| Application Number: SSI 7485  | Suburb: St Peters Postcode 2044   |
| Application Name: WestConnex M4-M5 Link   | Signature:  |

The EIS states in 6.5.8 Darley Road civil and tunnel site (C4) that:

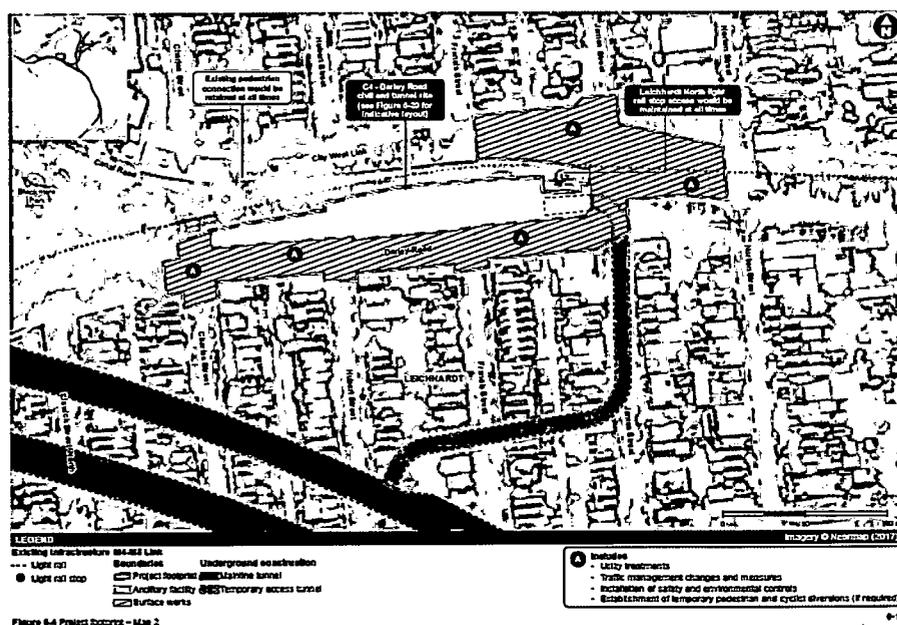
- I object to the EIS because it fails to describe the temporary changes to Darley Road, Leichhardt to enable access to and from the ancillary facility that would likely be required in relation to the Darley Rd site and instead allows for the final plan to be decided by the contractor.

It is not clear how continued access, pedestrian and cyclist movement will be preserved and I am concerned that the impacts have not been correctly identified and assessed by the proponent.

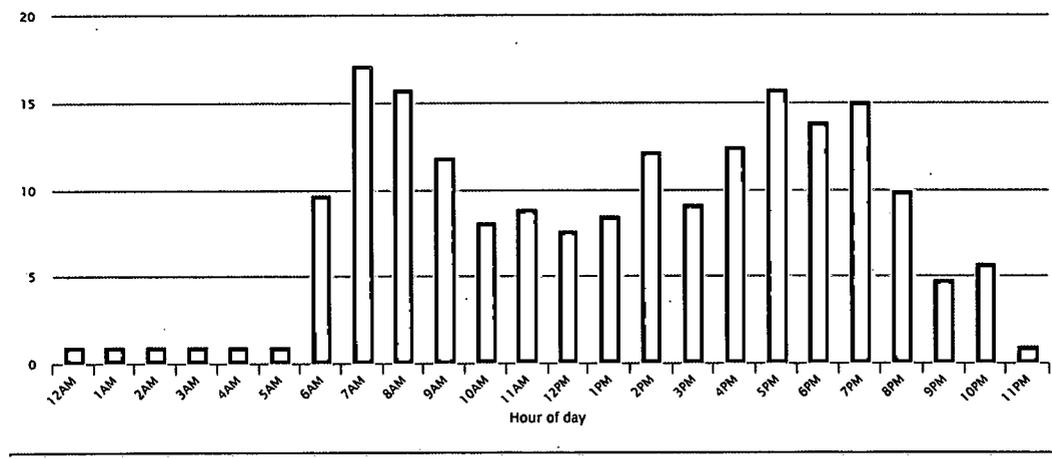
- I object to the EIS because the proponent has failed to take account of the cumulative impact of its proposed Darley Road, Leichhardt civil and tunnel site operations and the aircraft noise which the residents near the site already endure.

The attached extract from Webtrak shows that Darley Road, Leichhardt and adjacent streets are directly under the flight path.

Figure 6-4 Project features - Map 2

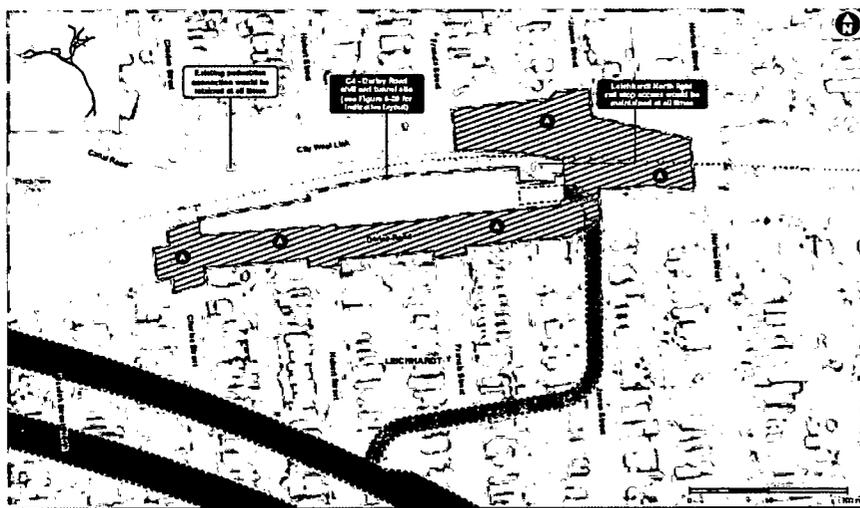
- I object** to the EIS because it does not guarantee that the existing access to the Leichhardt North light rail stop would be maintained at all times. Fig 6-4 indicates that only the eastern access will be maintained. This greatly disadvantages the elderly and disabled who have to walk up a steep hill to the eastern access. If the proponent cannot guarantee access to the Leichhardt North light rail stop from the existing entry points or from points that are accessible to all then the Darley Road, Leichhardt construction site should be abandoned. The proponent should be directed to find a site where its operations will not impact on users of the Light Rail.

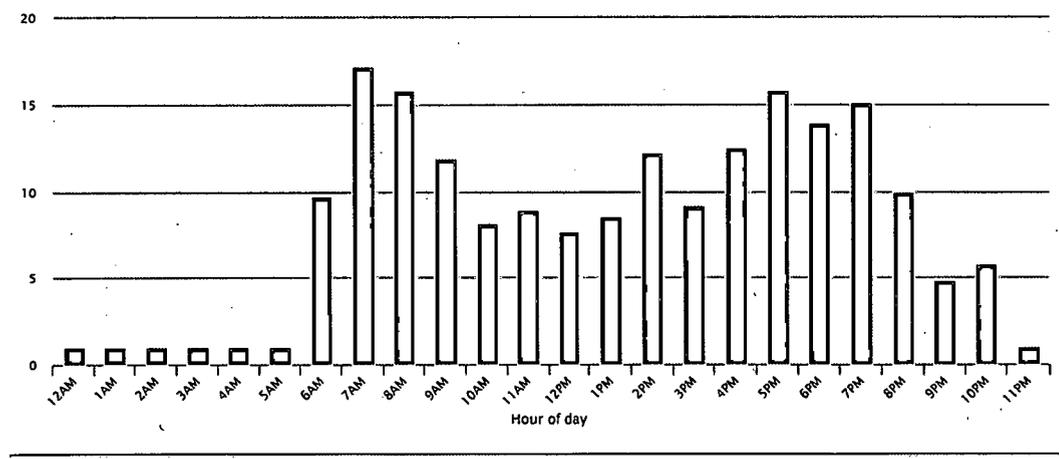
- I object to the EIS because the proponent has failed to take account of the cumulative impact of its proposed Darley Road, Leichhardt civil and tunnel site operations and the aircraft noise which the residents near the site already endure.

The attached extract from Webtrak shows that Darley Road, Leichhardt and adjacent streets are directly under the flight path.

The EIS states in 6.5.8 Darley Road civil and tunnel site (C4) that:

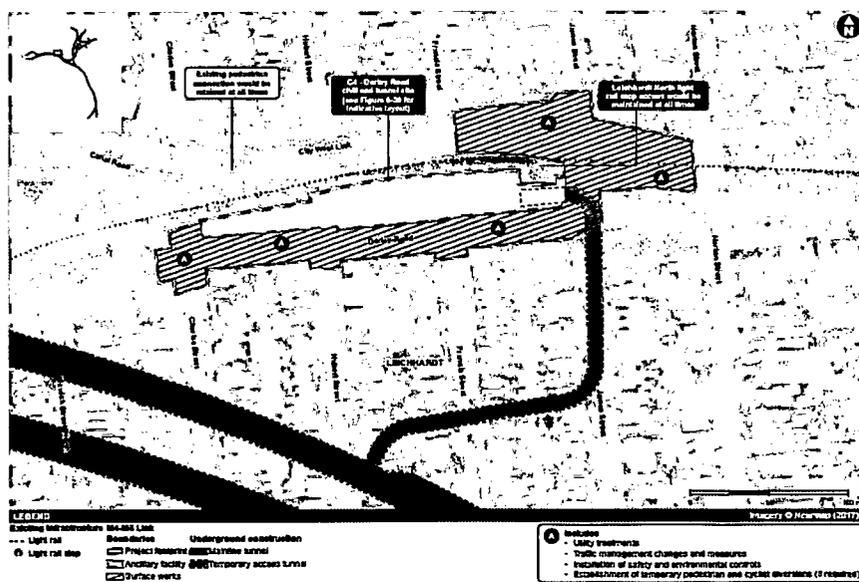
- I object** to the EIS because it fails to describe the temporary changes to Darley Road, Leichhardt to enable access to and from the ancillary facility that would likely be required in relation to the Darley Rd site and instead allows for the final plan to be decided by the contractor.

It is not clear how continued access, pedestrian and cyclist movement will be preserved and I am concerned that the impacts have not been correctly identified and assessed by the proponent.

The EIS states in 6.5.8 Darley Road civil and tunnel site (C4) that:

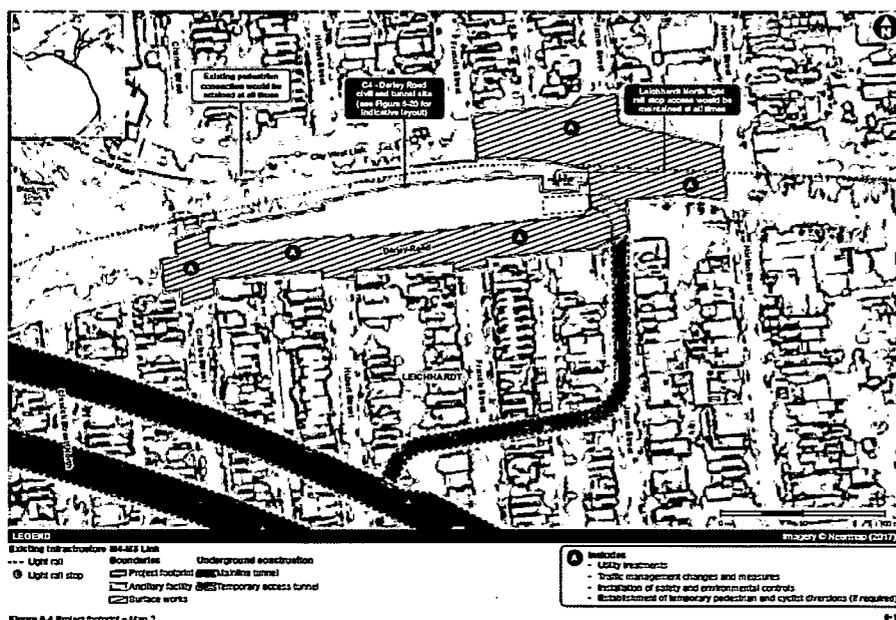
1. I object to the EIS because it fails to describe the temporary changes to Darley Road, Leichhardt to enable access to and from the ancillary facility that would likely be required in relation to the Darley Rd site and instead allows for the final plan to be decided by the contractor.

It is not clear how continued access, pedestrian and cyclist movement will be preserved and I am concerned that the impacts have not been correctly identified and assessed by the proponent.
